<b>DOCKET</b>	
<b>08-AFC-13</b>	
DATE	APR 20 2010
RECD.	APR 20 2010

RE: Calico Solar Project  
 Applicant's Submission of Additional Information from April 16<sup>th</sup> Workshop

Tessera Solar, on behalf of the Applicant, hereby submits additional information requested during the April 16<sup>th</sup> workshop.

**CALICO SOLAR PROJECT LAYOUT**

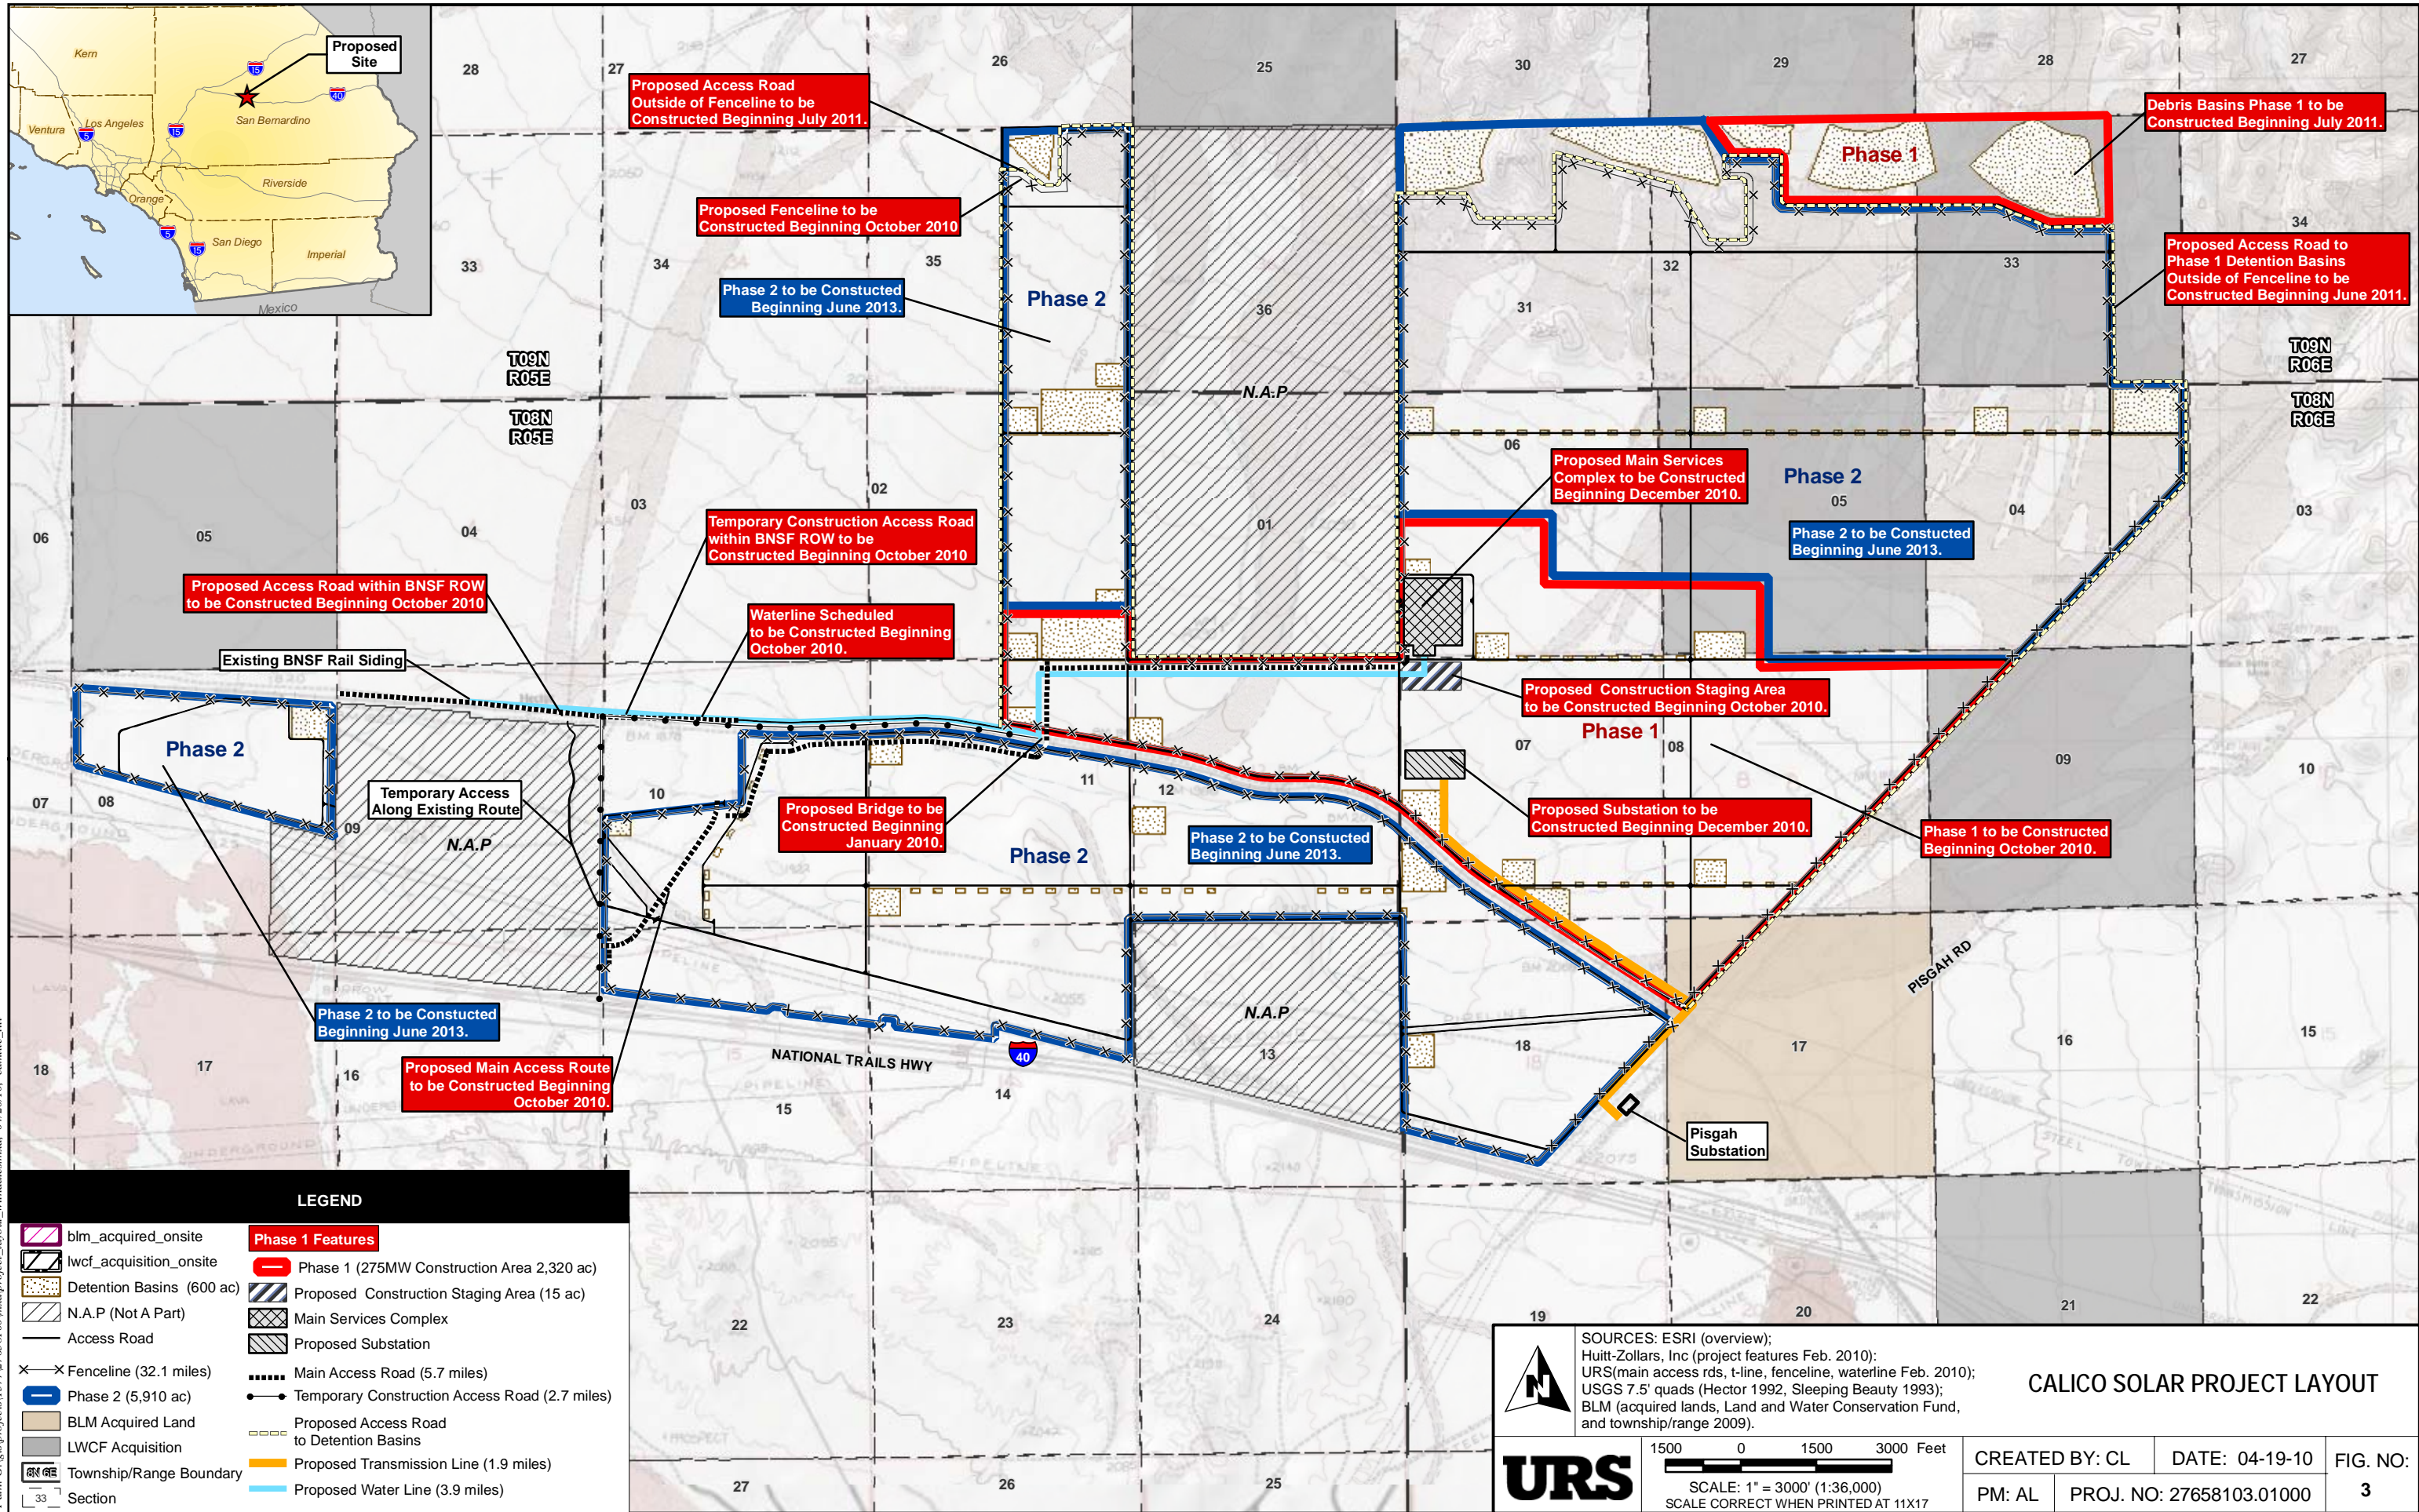
**Prepare a figure depicting the proposed schedule for Project development:**

The requested map is provided as Attachment A to this response.
